May 28, 2009

Subject: Comments on GRU January 30, 2009 Technical Memorandum entitled “*Evidence of DNAPL Movement at Koppers Site,*”

ATTACHMENT 1
DETAILED RESPONSE TO GRU TECHNICAL MEMORANDUM
“EVIDENCE OF DNAPL MOVEMENT AT KOPPERS SITE, JANUARY 30, 2009”

Figure 6. Surficial Aquifer Water Levels.

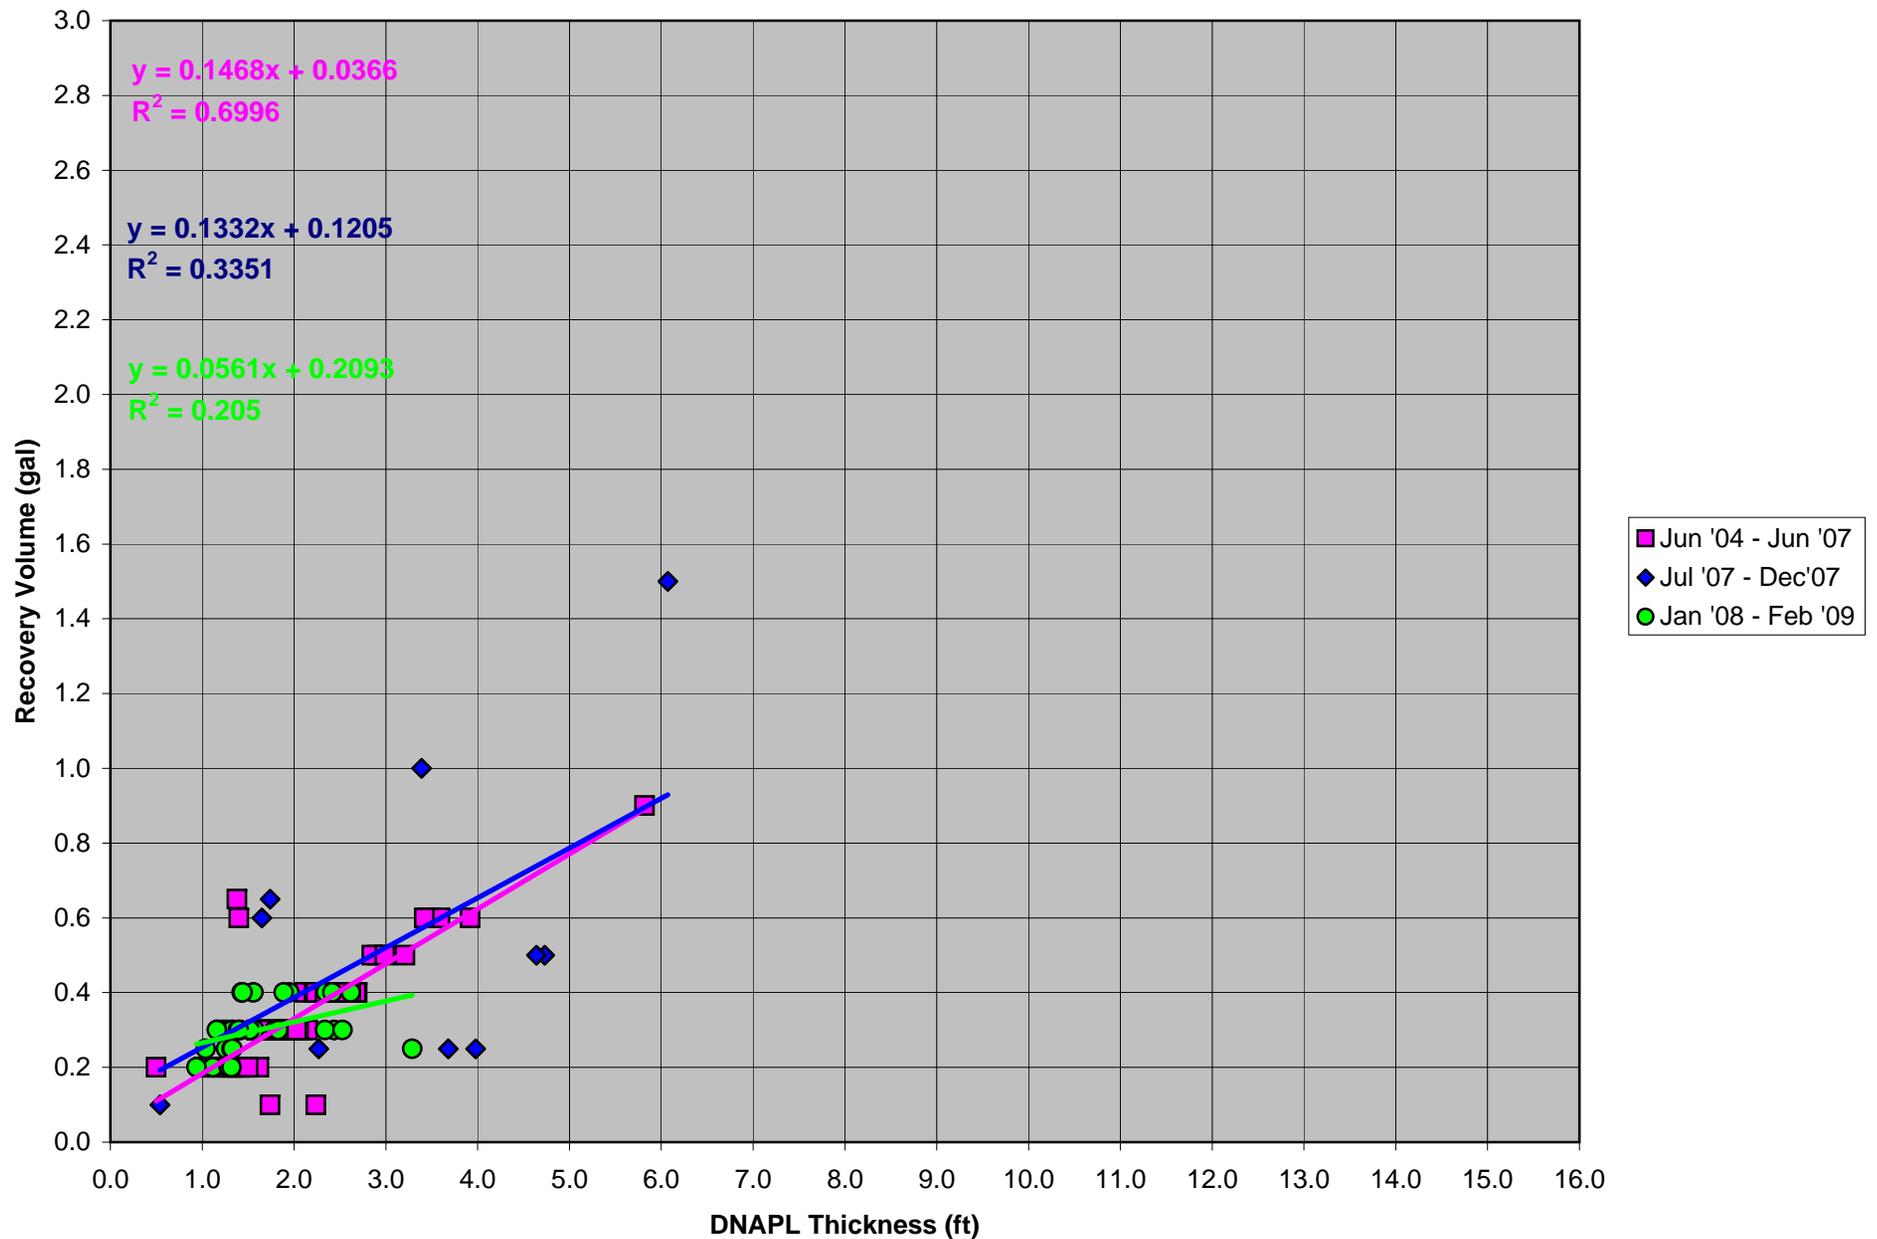
select wells appears reasonable prior to December 2007, a consistent time period when data for the majority of the wells appeared reasonable was chosen for the analysis. **Figures 1 through 5** show a plot of DNAPL thickness versus recovered DNAPL volume for wells HG-10S through HG-16S, respectively.

The linear regression of DNAPL thickness versus recovered volume for each of the five HG DNAPL wells for the time period July to December 2007 is poorly correlated and not consistent with pre-July 2007 data. The R^2 value for these data ranged from 0.05 to 0.74, with an R^2 value of less than 0.35 for three of the five wells. An R^2 value of 0.05 (HG-15S) basically indicates that there is little correlation between the measured thicknesses and recovered volumes. Note that the reported increase in DNAPL thicknesses and recovered volumes for well HG-15S is the primary basis for the current GRU conceptual model of on-going DNAPL mobility.

The linear-regression coefficient for feet of DNAPL in the well versus recovered volume ranged from 0.036 to 0.21, indicating that recovered volumes of DNAPL versus measured thicknesses were highly variable between wells and inconsistent with pre-July 2007 data. Well HG-15S had the lowest regression coefficient of 0.036, indicating that for every foot of DNAPL measured in the well, only 0.036 gallons of DNAPL were recovered. This is a physical impossibility given that at a minimum there should be 0.162 gallons of DNAPL for every foot of DNAPL in a 2-inch well. If additional DNAPL is contained in the filter pack outside of the screen, the volume could be greater than 0.162 gallons. Hence, the linear regression coefficient for data collected during this time period (July-December 2007) indicates that either the reported thicknesses and/or recovered DNAPL volumes are inaccurate for HG-15S. The regression analyses for the remaining four wells indicate similar issues with data collected during this time period (see **Figures 1** through **5**).

The R^2 values for January 2008 to February 2009 data range from 0.04 to 0.205. Again, the lowest R^2 value of 0.04 for this time period was for well HG-15S. This is consistent with the plotted data points (**Figure 4**) where the recovered DNAPL volumes vary considerably for the same approximate DNAPL thicknesses measured during this time period. The low R^2 values for the data collected during this time period indicate a poor correlation between measured thicknesses and recovered volumes. However, with the exception of HG-15S, the majority of the DNAPL thicknesses and recovered volumes are within the range of thicknesses measured pre-July 2007. The low R^2 values for this subset of data are partially due to the fact that the thicknesses and recovered volumes for each of the wells are not changing much over this time period. Because of the narrow range of data values, small inaccuracies in these measurements results in a lower R^2 value, even though the data appear to be reasonable on the plots.

Figure 7. Annual precipitation 1980 to 2008 for Gainesville, Florida.

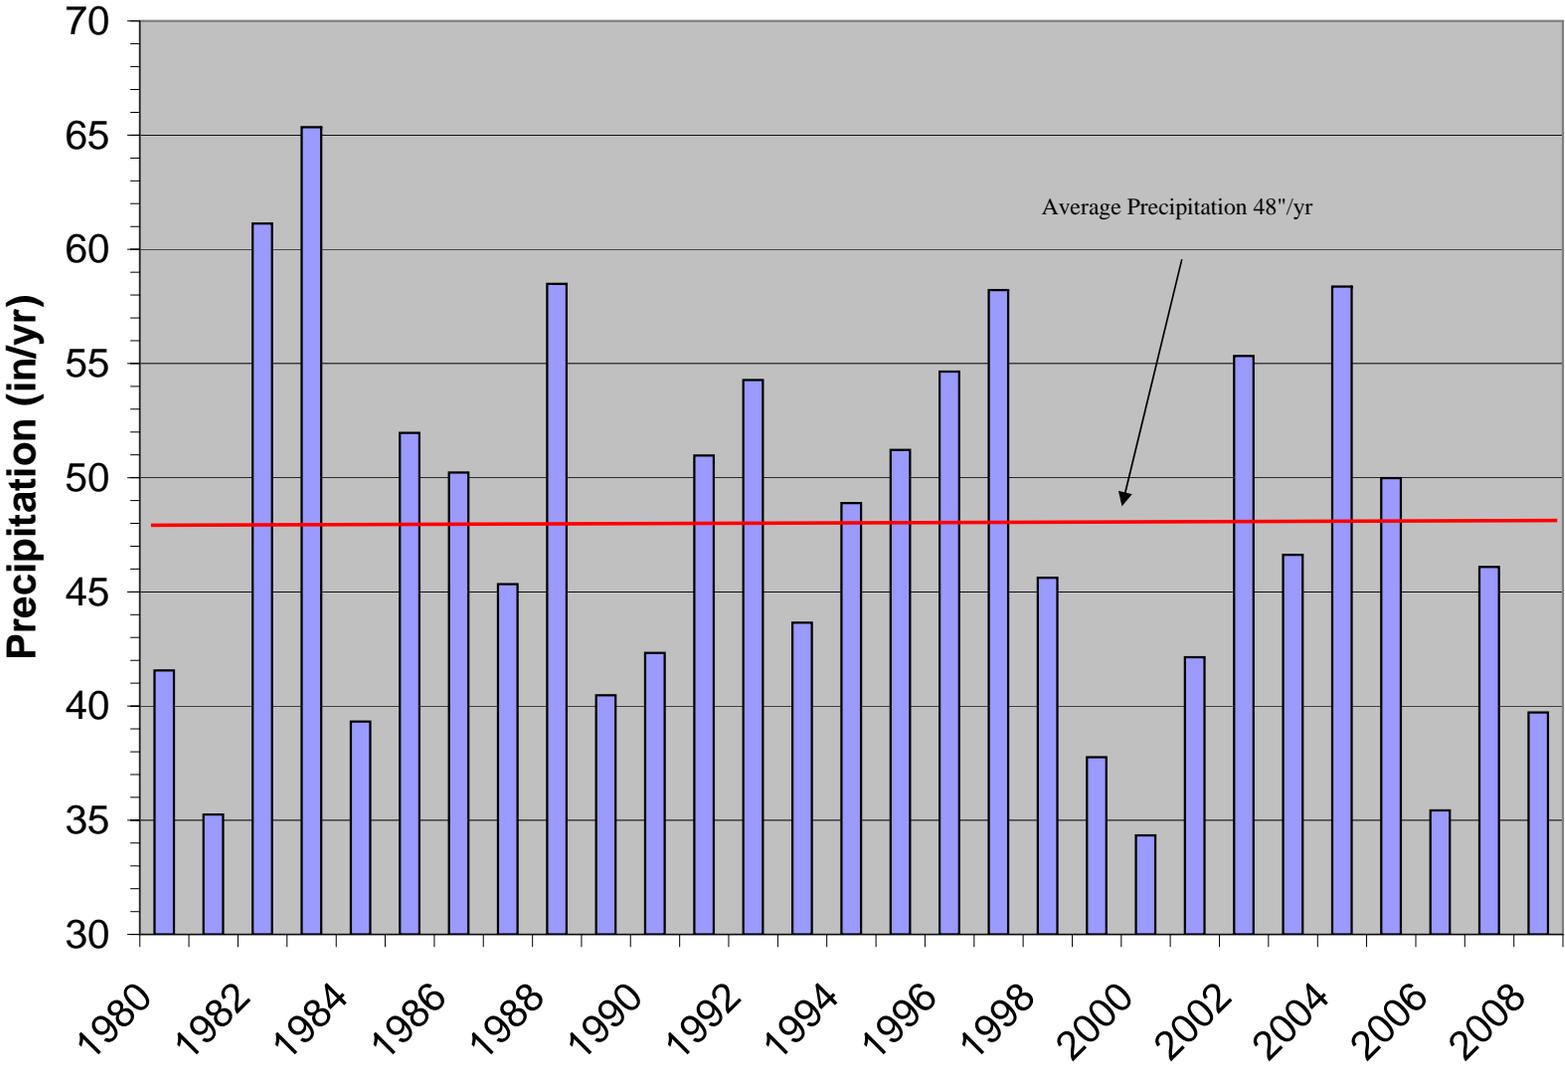
Given this conceptual model there are 15 annual periods since 1980 when the annual precipitation was less than 48 inches in Gainesville (**Figure 7**). Years of below average precipitation should correspond to years when the Surficial Aquifer water levels declined. Based on the GRU conceptual model, DNAPL would have been released from the pores during the first water table declined after the pores became saturated with DNAPL. The most recent sustained period of water-table decline would have occurred during the 5 year period 1997 to 2001 where precipitation continually declined from a high of 58 inches to a low of 34 inches in 2000 (**Figure 7**). During this 5- year drought, water levels in the Surficial Aquifer would have declined substantially and virtually all DNAPL above the air-DNAPL-Water saturation value would have been released. Given that there are multiple cycles of precipitation of less than 48 inches/year since

Figure 8. Well HG-15S DNAPL thickness measurements pre-bailing, post-bailing and end day.

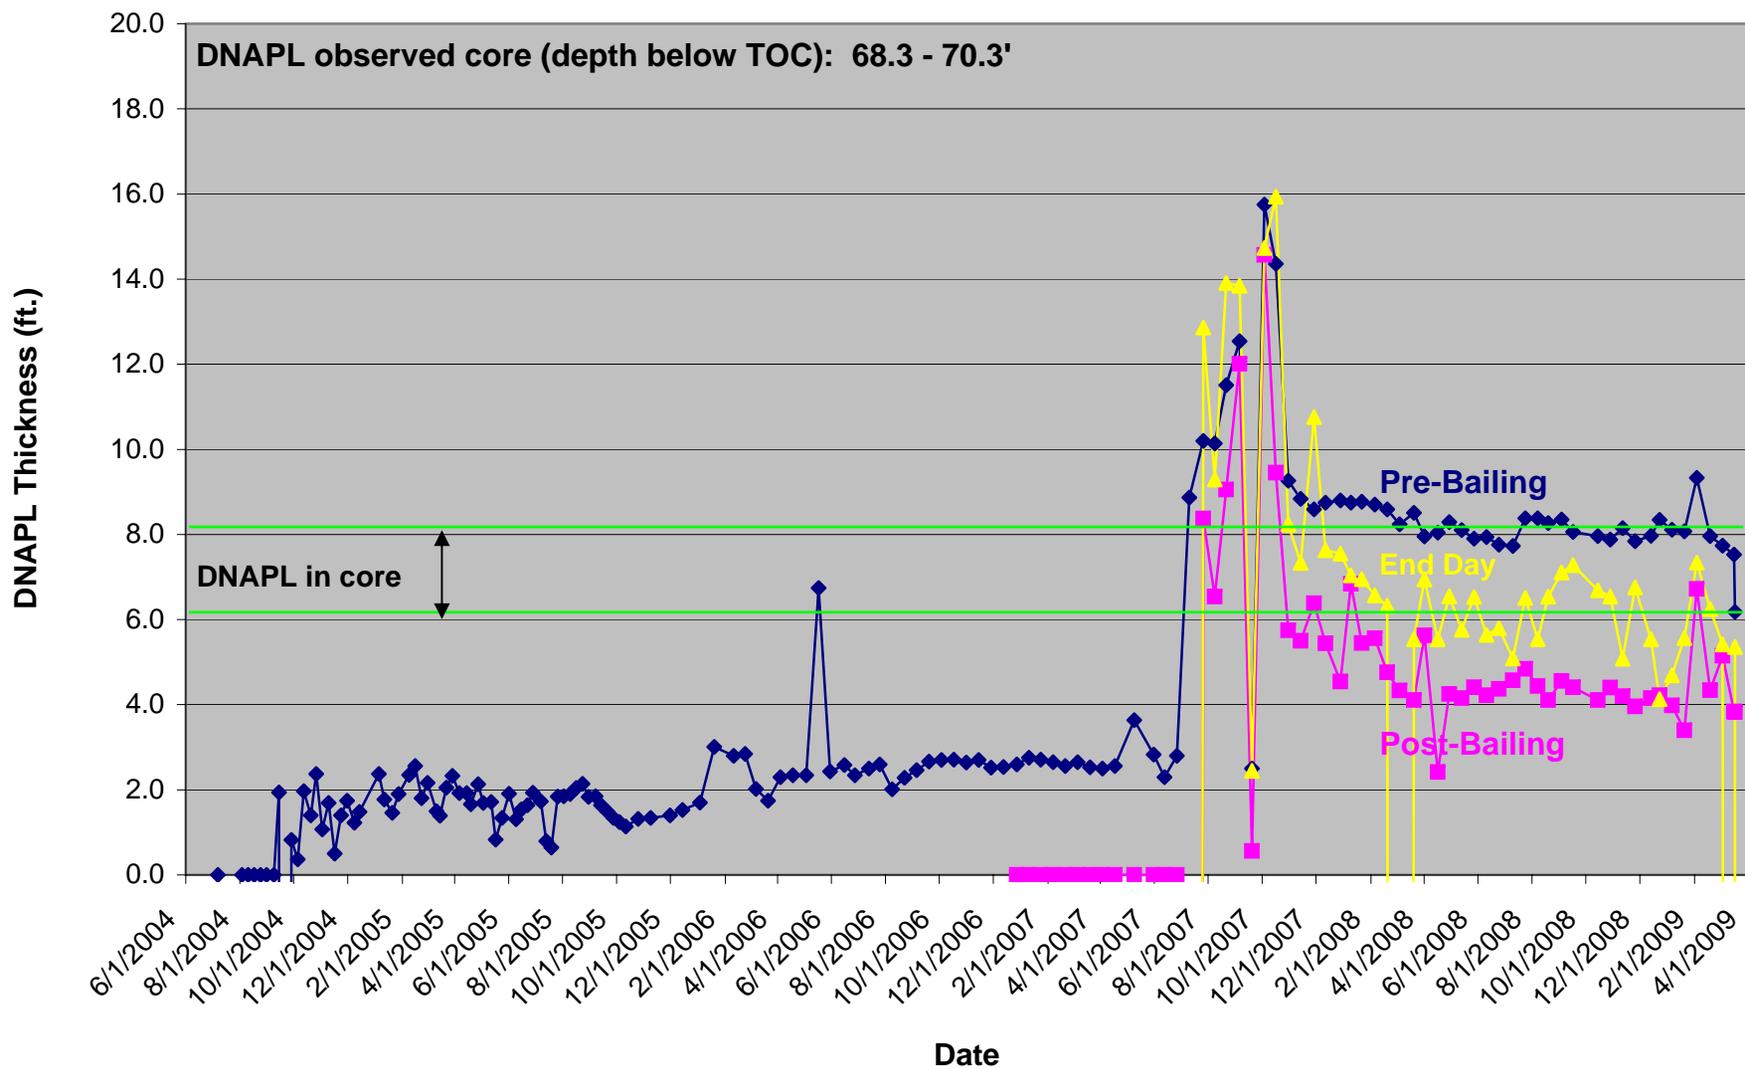
A plot of DNAPL thickness in well HG-15S shows a fairly constant thickness of about 1.7 to 2 feet from 2004 through 2005 (**Figure 8**). Beginning in 2006 the DNAPL thickness in this well increased to over 2 feet, with an average thickness of approximately 2.3 feet. The thickness remained fairly constant in this well until July 2007. With the change in the O&M contractor in July 2007, the data became very erratic with extreme thicknesses being reported for the remainder of 2007. Beginning in 2008 and continuing into 2009 the reported DNAPL thickness in this well fluctuated with an average thickness of approximately 8 feet. As indicated by the GRU Team, the average DNAPL thickness in this well increased approximately 5 feet from the pre-July 2007 thicknesses. The GRU Team flawed conceptual model for this apparent increase in DNAPL thickness is

substantially higher than the “Pre-Bailing” measurement for that event (**Figure 8**). The elevated DNAPL thicknesses recorded for the “End Day” are not reproducible in the subsequent “Pre-Bailing” DNAPL recovery measurements. Further, it has been observed by the present O&M contractor that DNAPL recovery to “Pre-Bailing” levels requires days to weeks to complete; however, the “End Day” measurements were performed within hours of completing DNAPL removal in these wells.
